**Addendum No. 2
February 16, 2023**

Project: Harrisburg Elementary School #8
Harrisburg, South Dakota
Architecture Incorporated Project #3000

Architect: Architecture Incorporated

4.33

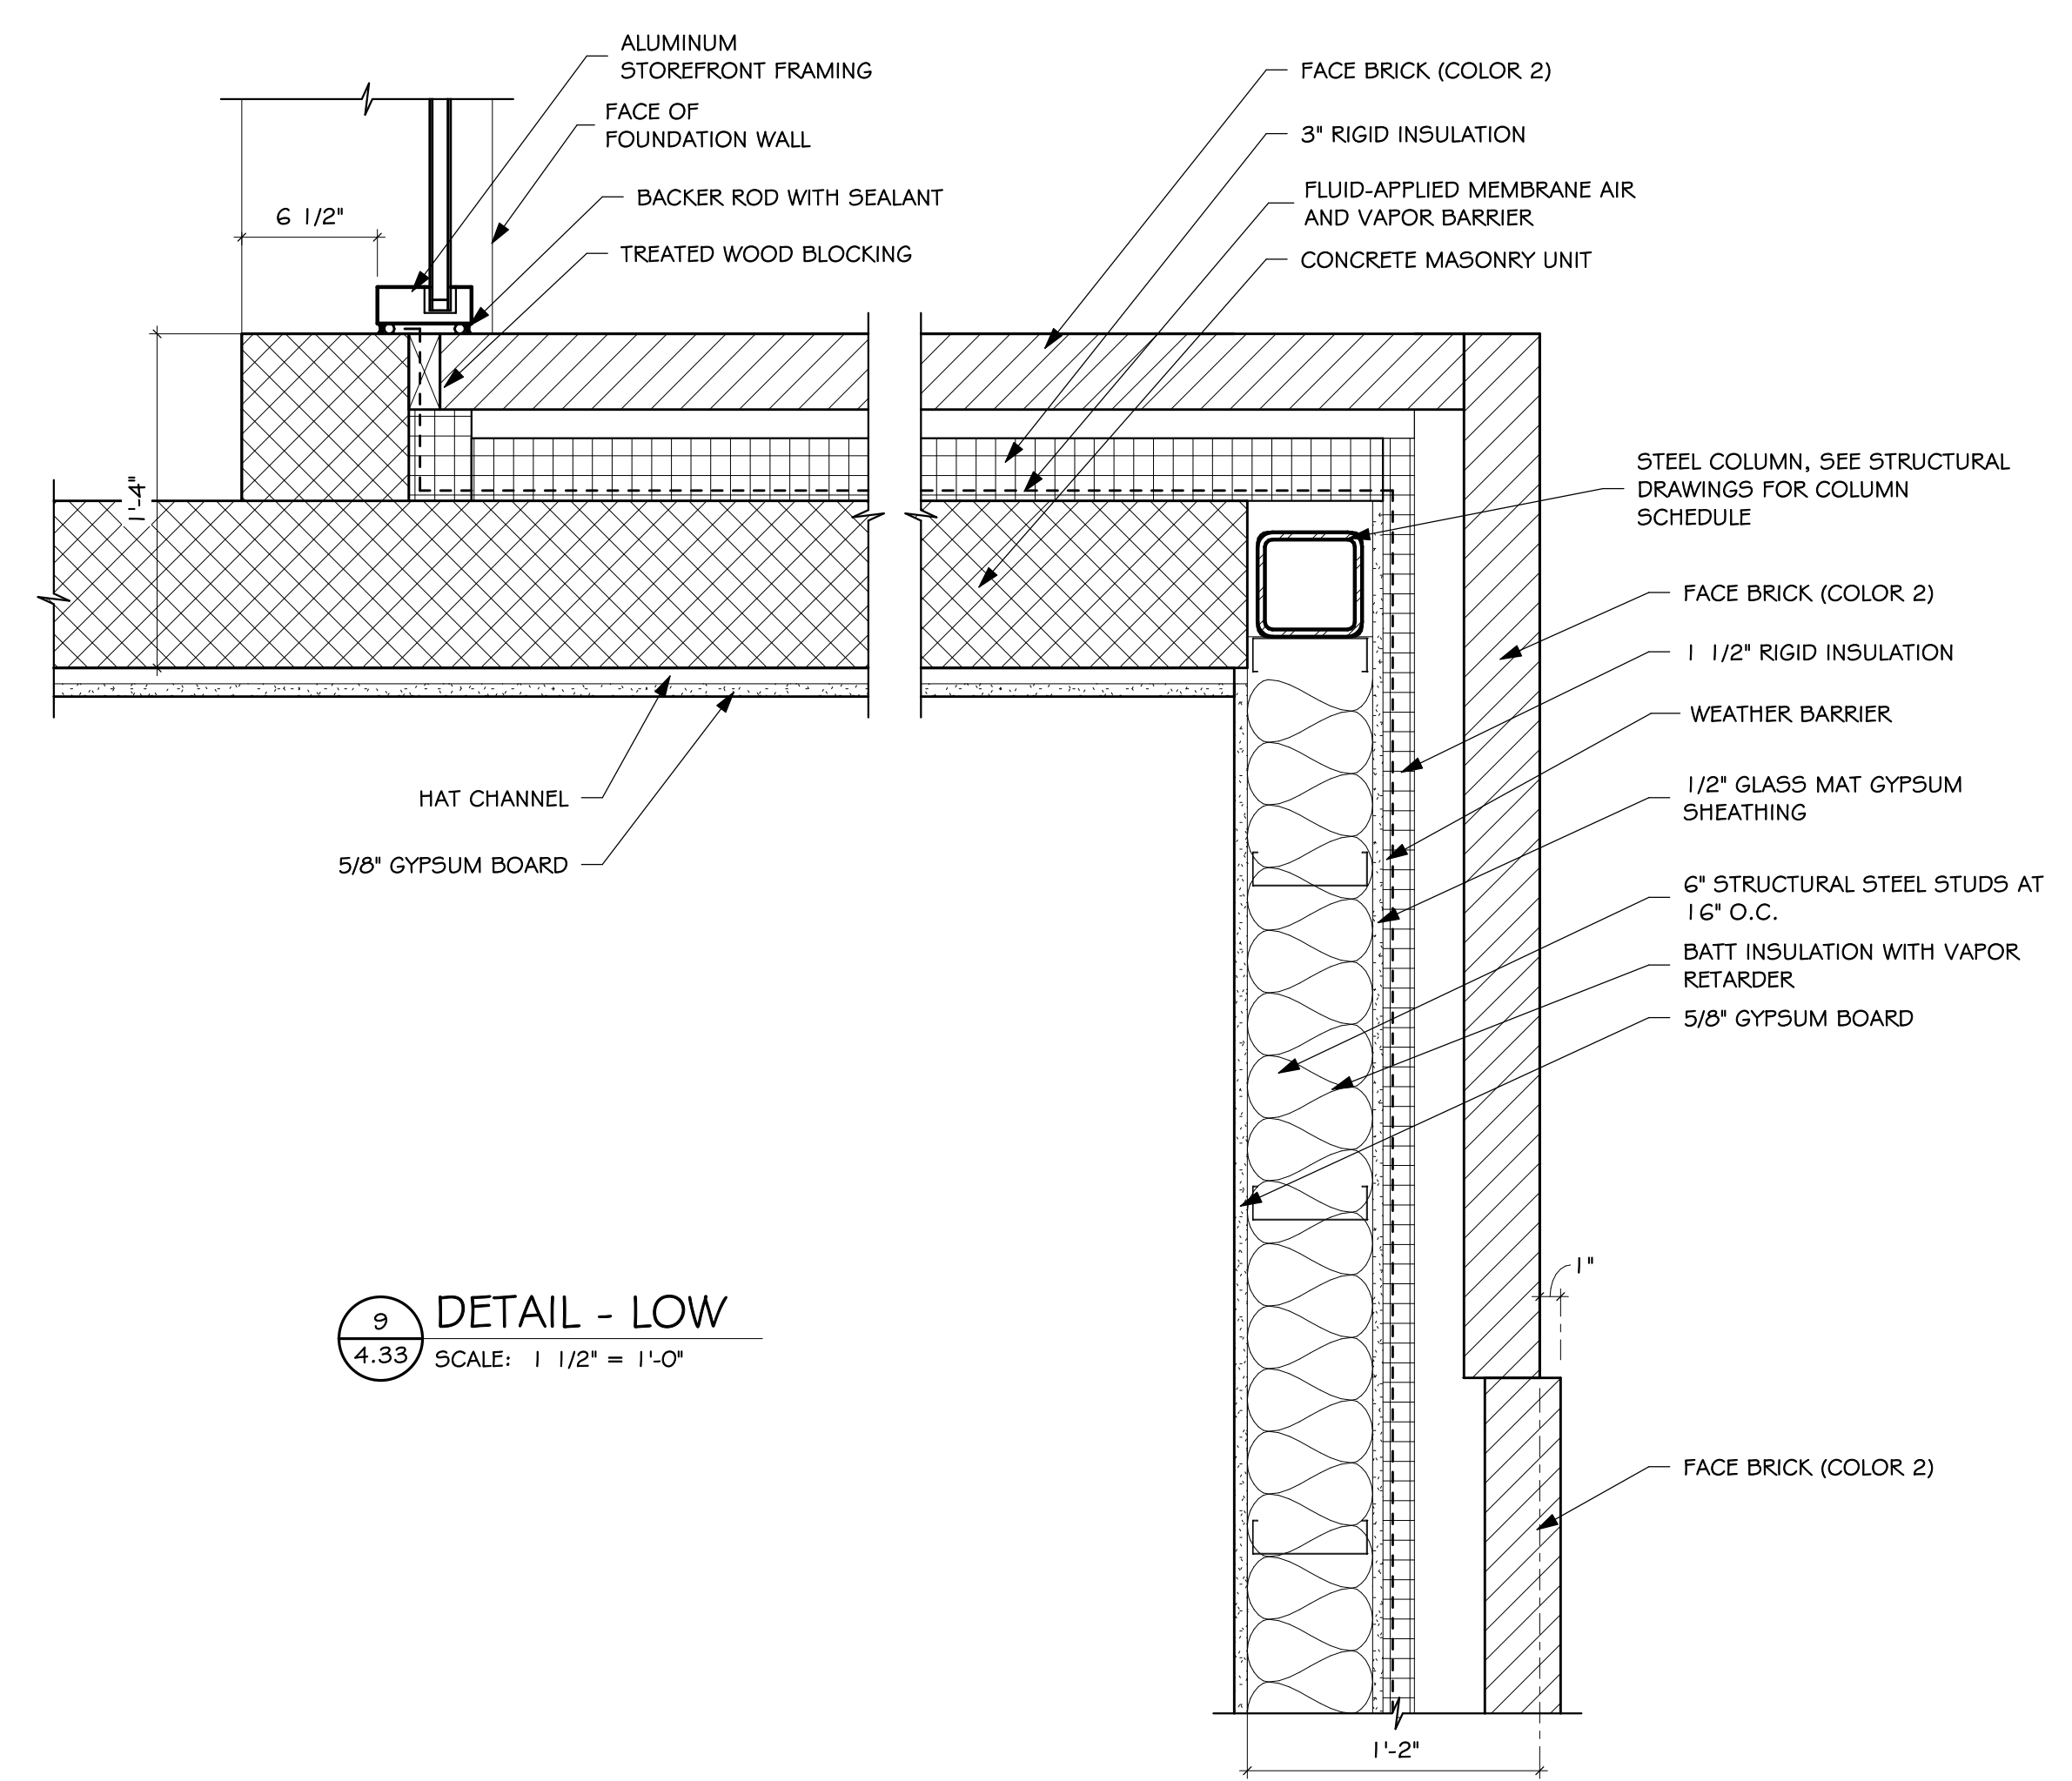
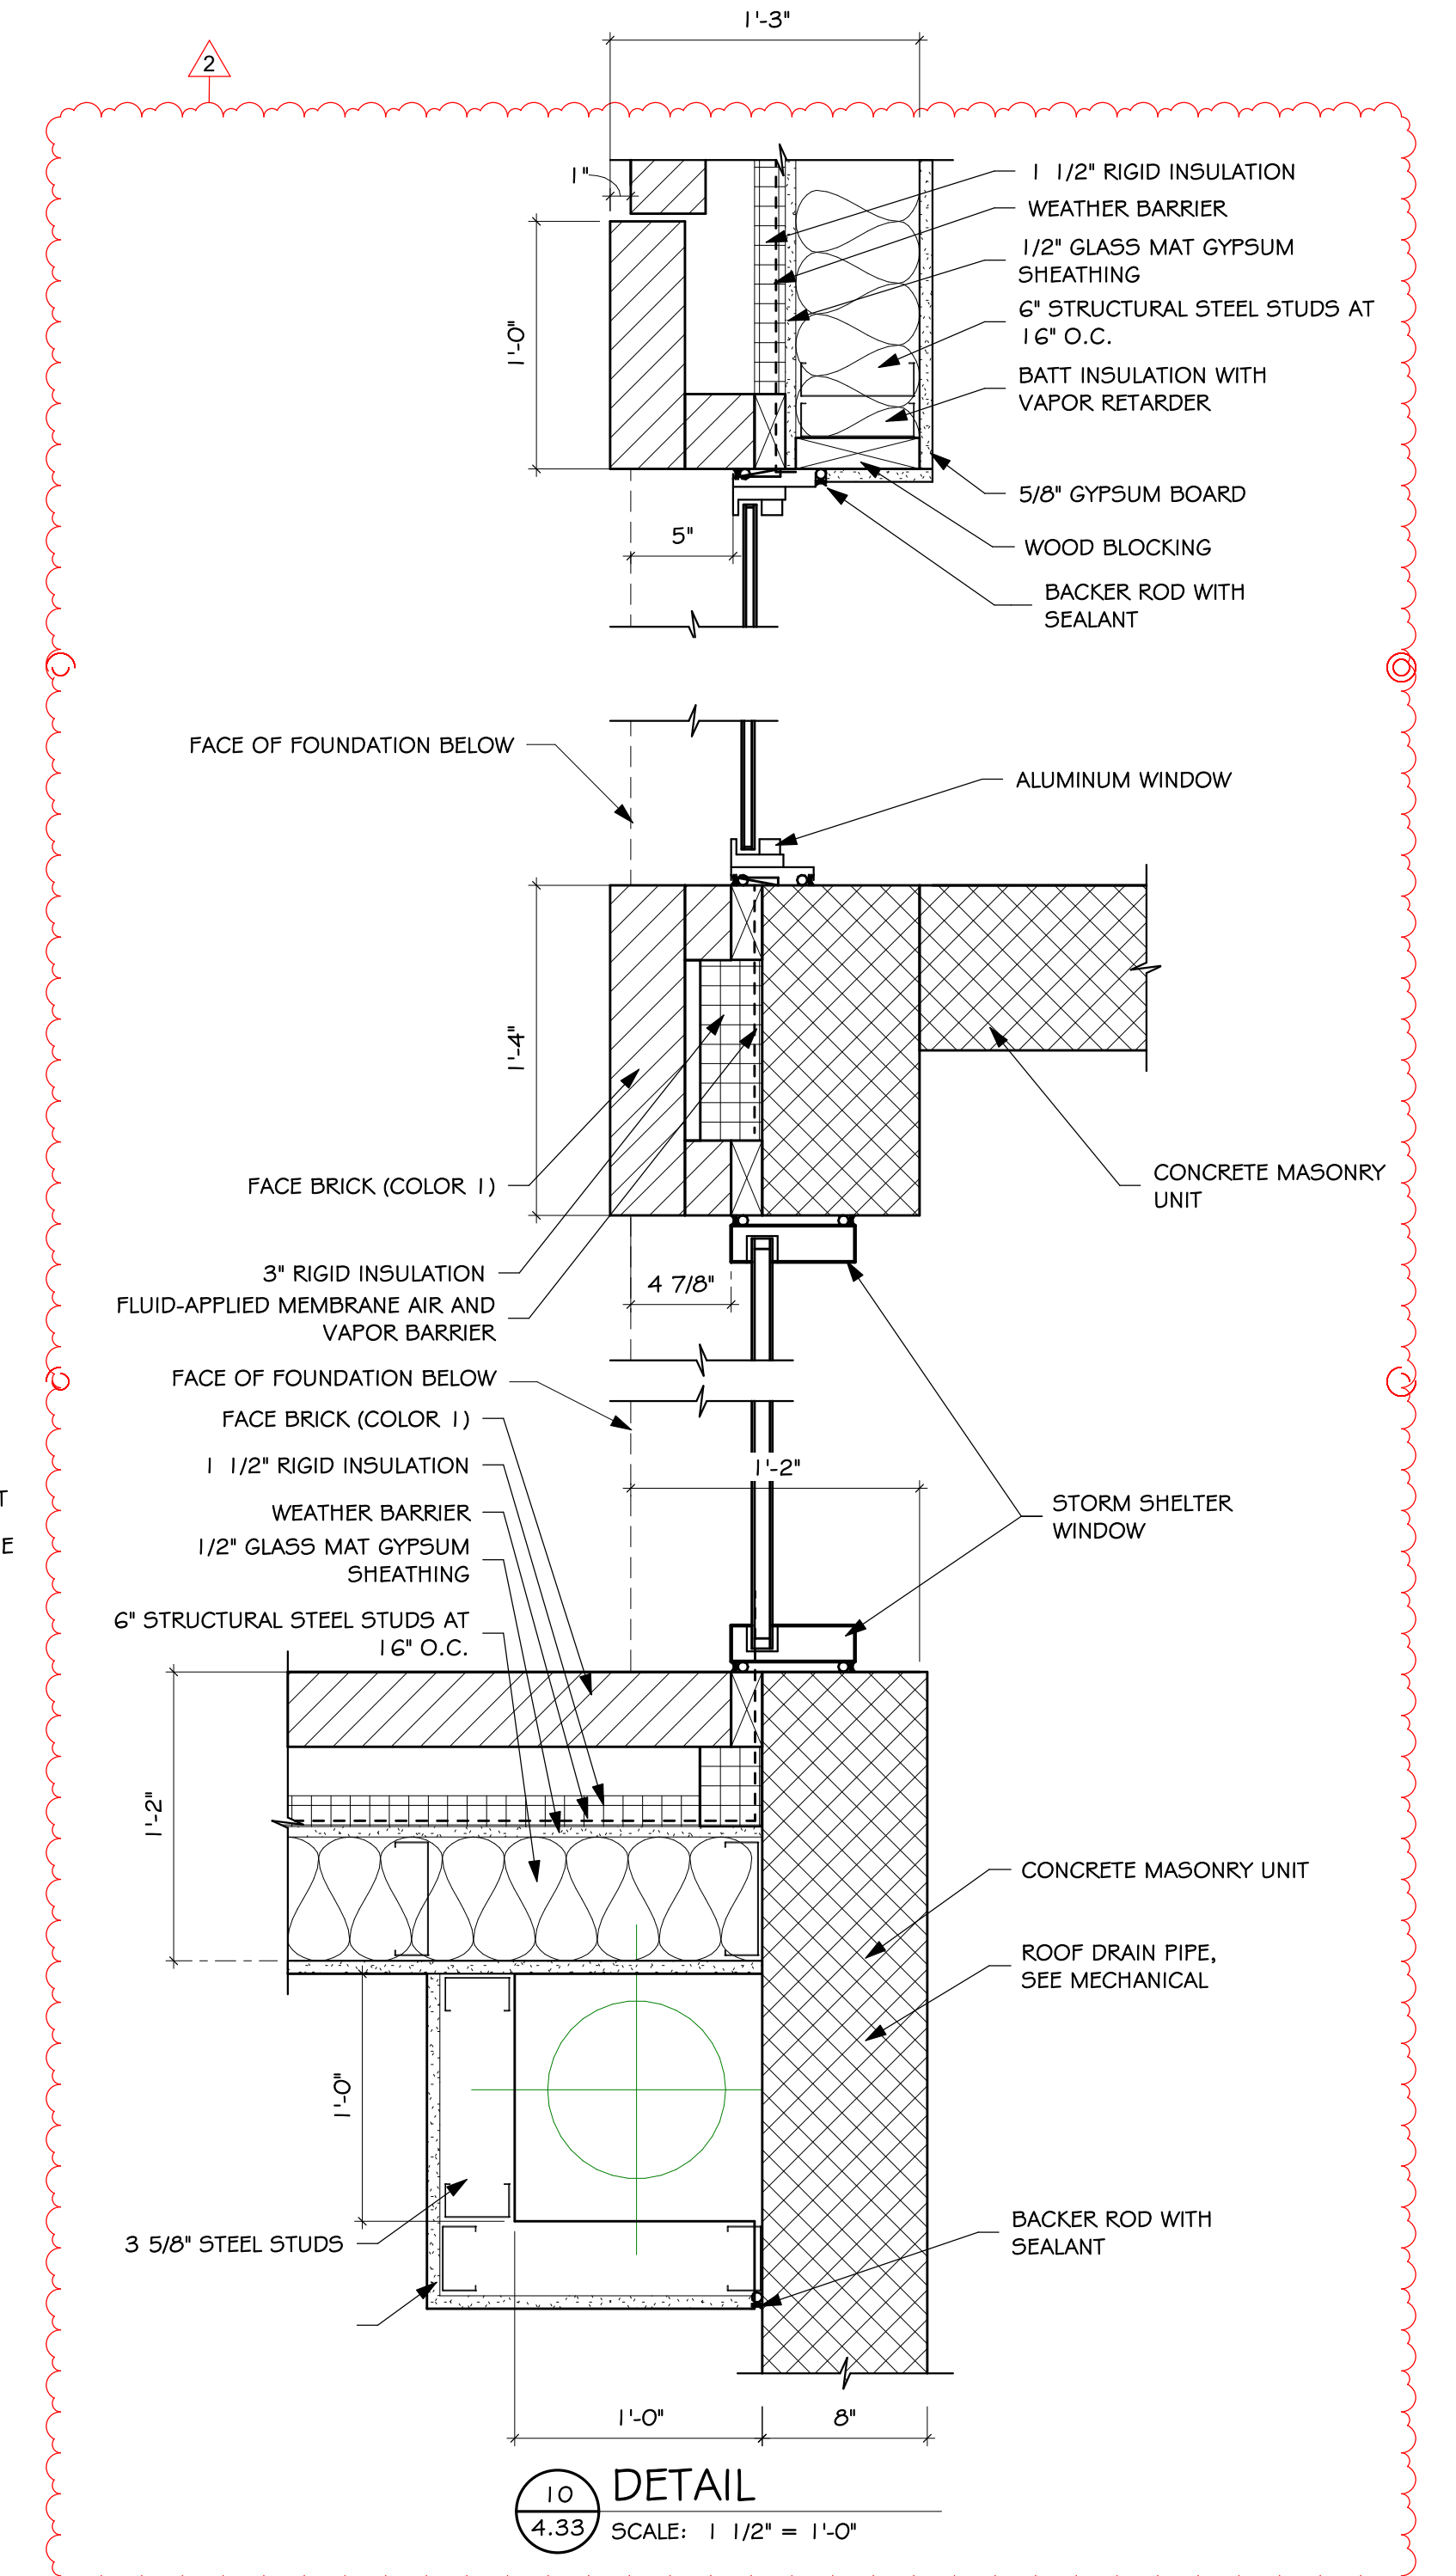
- a) Revise storefront jamb details 1/4.33 and 4/4.33; reference *revised* drawing Sheet 4.33, dated 2-16-23, attached to the end of this addendum for revised details.
- b) Revise (Type F) storm shelter window jamb detail 10/4.33 as indicated per *revised* drawing Sheet 4.33, dated 2-16-23; see revised drawing Sheet 4.33 attached to the end of this addendum for additional information.
